**Re: Response to Peer Review Comments #2
Shantz Station Pit – Noise Impact Assessment
Part of Lots 81 and 82, German Tract Company
Breslau, Ontario
VCL File: 118-0188**

FIGURE 2: BERM AND STOCKPILES SURROUNDING PROCESSING PLANT

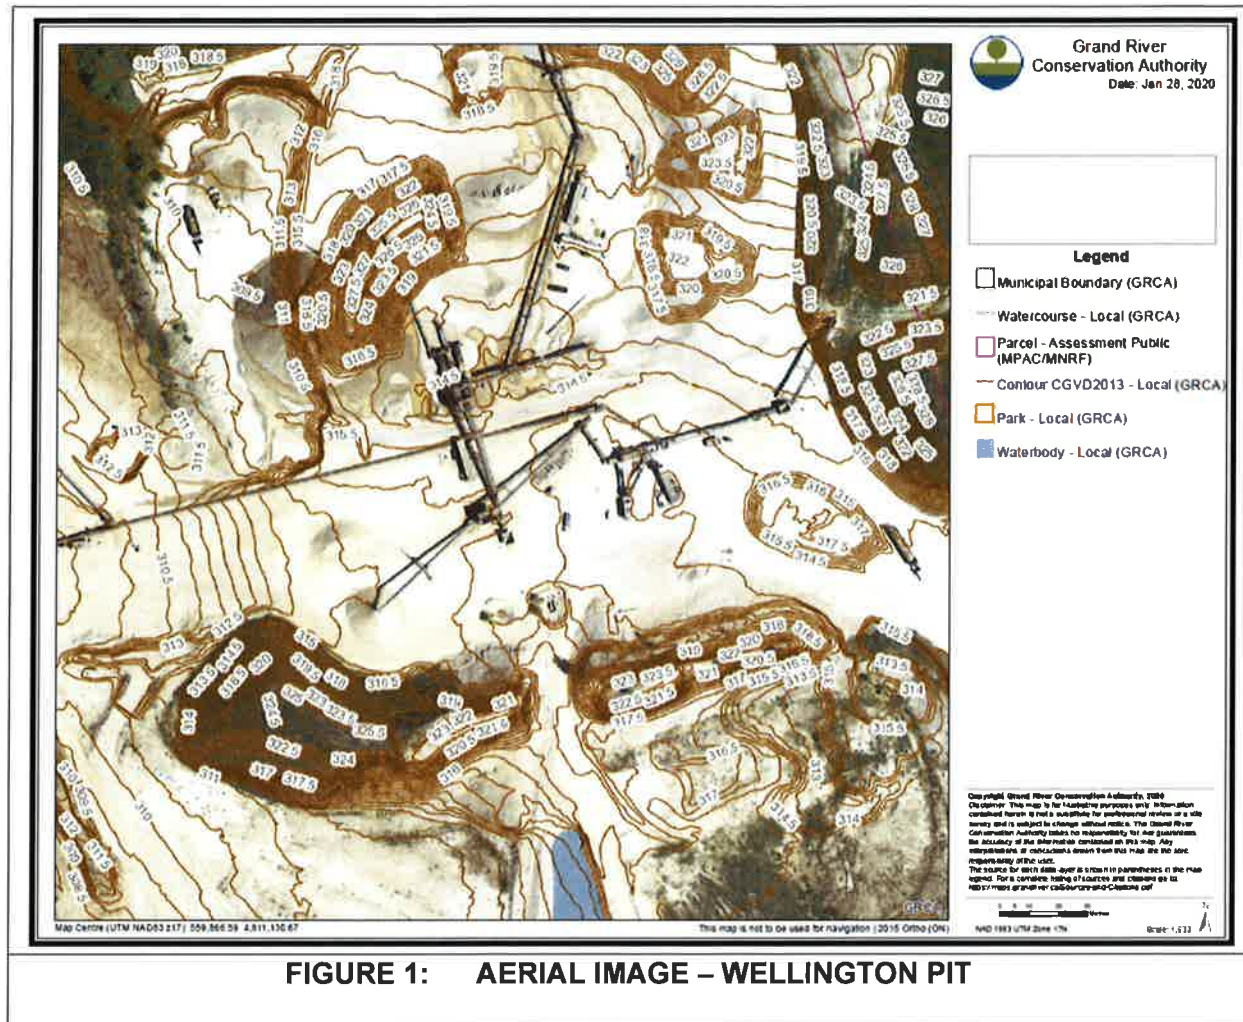
Comment #3 – Barrier and Berm Recommendations (Section 4): *The explanation provided by VCL in regards to the stability of the constructed berms/barriers is somewhat beyond our scope of acoustical engineering work as VCL is providing a position that such berms can be much higher using “telescoping radio stackers”. Such details should be vetted by the Site Engineering Consultant as stability of a berm is not an issue that we deal with, except to flag any berm height to base ratio that may not present a stable situation or where such height could cause a significant loss of floor space. Note that VCL is showing a very thin green line, which could be interpreted to be a sound barrier wall 11m high, equivalent to a four storey building.*

VCL Response: It is not uncommon for product stockpiles and berms to be used as sound barriers around processing plants at aggregate operations. Capital will employ the same approach at the Shantz Station Pit. The size of Phase 1 has been developed to account for the space required to accommodate such berms and product stockpiles to act as sound barriers.

To help clarify the barrier recommendations surrounding the processing plant, an aerial image and photos of the Wellington Pit, operated by Capital Paving Inc., are included as Appendix A.
